July 14, 2021

**Re: Kenzo Estate Vineyard, Napa County ECP – Response to Napa County comments on biological resources (File # P21-00086-ECPA)**

**Figure A-1. Oak Woodlands**

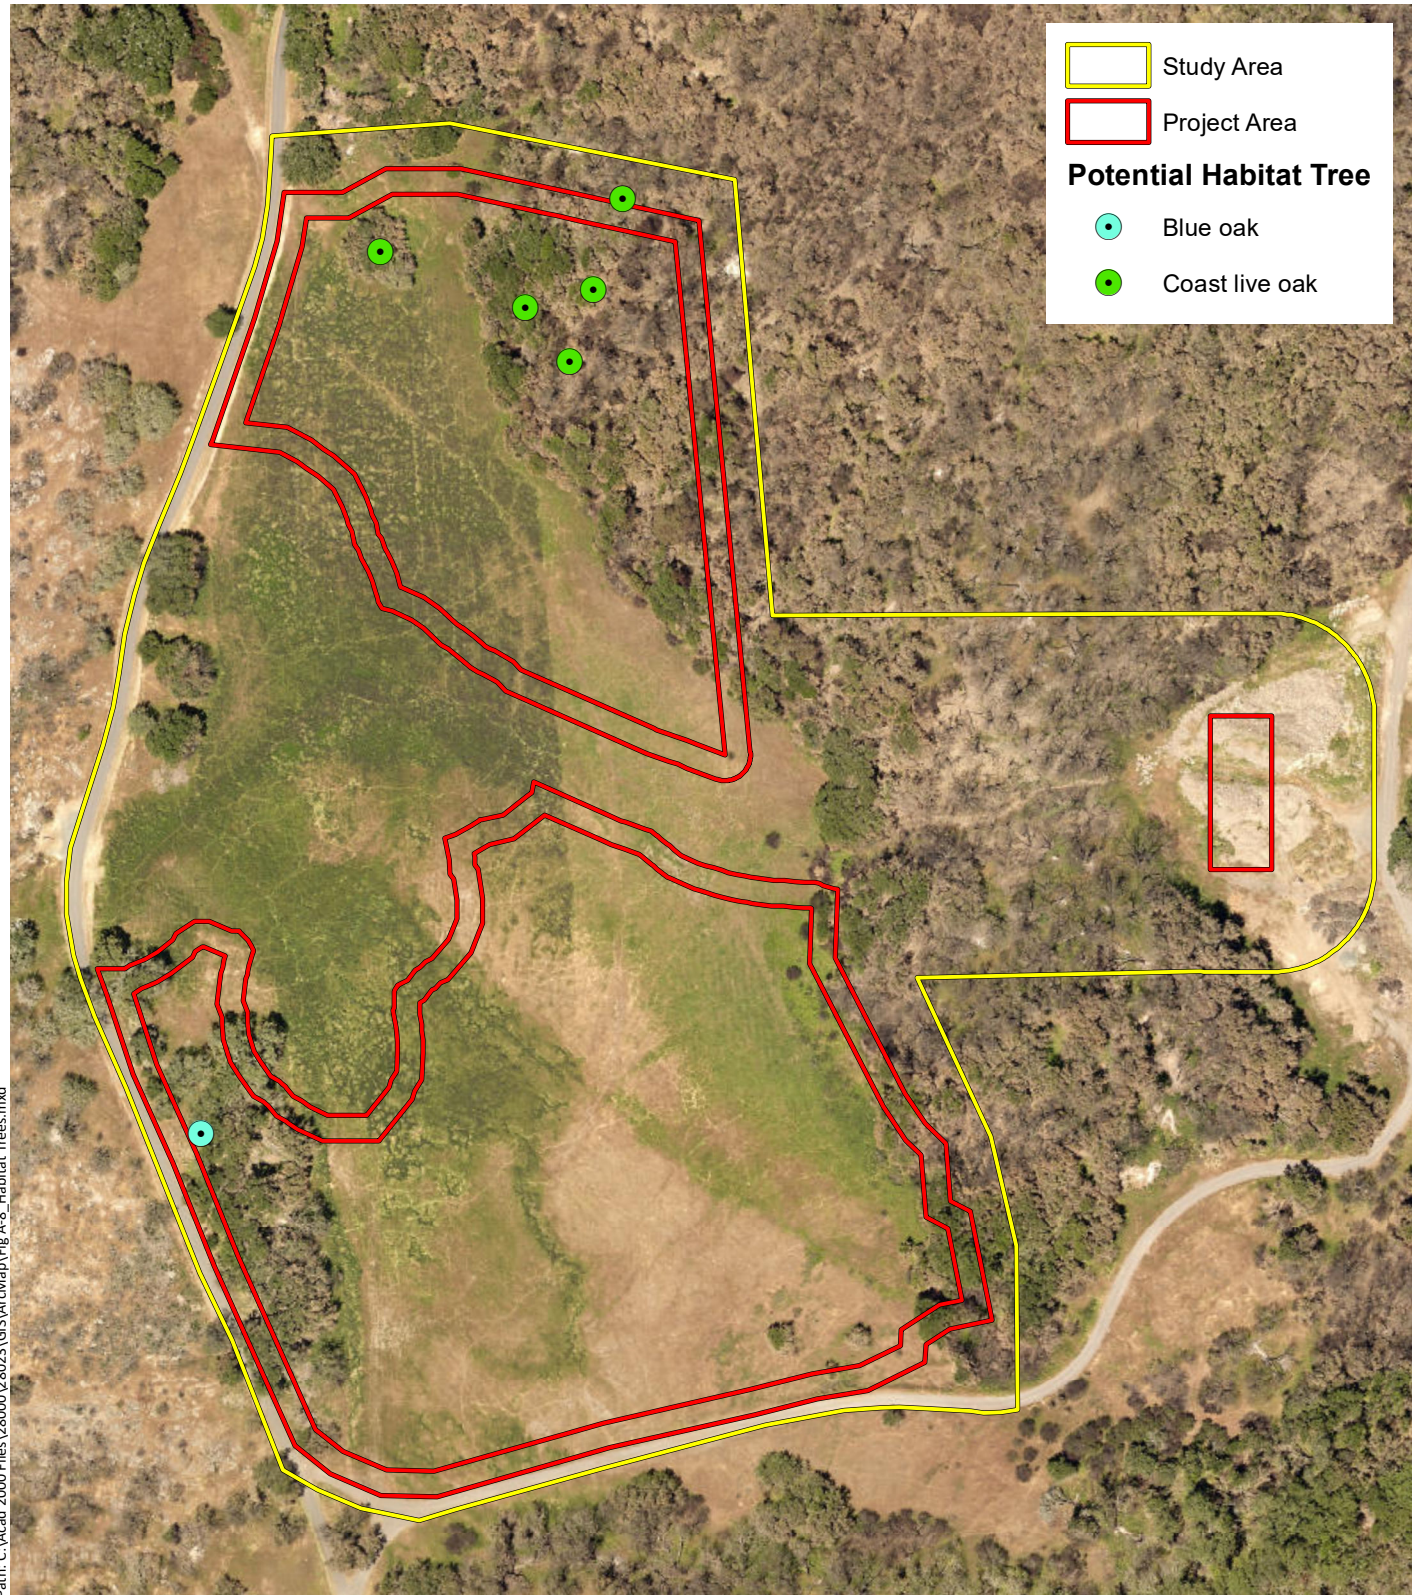
*i-ii. Figure A-7 does not include APN 033-190-014...Please revise aerial baseline and [BRRS report] Section 6.1.1 regarding vegetation removal and retention accordingly.*

*ii. Please provide details of oak woodland acreage and proposed removal on each parcel to evaluate the requirements for retention and mitigation pursuant to Conservation Regulations 18.108.020(D) and 18.108.027(B) for each parcel.*

- i. Figure A-7 does not include APN 033-190-014 (refer to 1(a)(i), above). While it is understood that oak woodland is not proposed for removal on this parcel, the parcel is still subject to the vegetation retention requirements found in Napa County Code 18.108.027(B) and General Plan Policy CON-18, which require that projects in sensitive domestic water supply drainages maintain a minimum of 70% tree canopy cover and 40% of the shrub, brush and associated annual and perennial herbaceous vegetation on the project parcels as configured on June 16, 1993. Please revise aerial baseline and Section 6.1.1 regarding vegetation removal and retention accordingly.

- ii. Please provide details of oak woodland acreage and proposed removal on each parcel to evaluate the requirements for retention and mitigation pursuant to Conservation Regulations 18.108.020(D) and 18.108.027(B) for each parcel.

The extent of oak woodlands and proposed impacts to these woodlands on a per-parcel basis is shown in Figure A-1 (Attachment A) and summarized in Table 1.

Parcel (APN)	Oak woodlands present (acres)	Proposed impacts (acres)	Percent retention
033-190-014	12.1	0.0	100
033-190-015	58.7	1.7	97
033-130-046	140.7	1.5	99

As is the case with the two primary project parcels in aggregate (outlined in the BRRS report), retention of oak woodlands within each of the three respective project parcels substantially exceeds County General Plan requirements for oak woodland (acreage) and canopy retention.
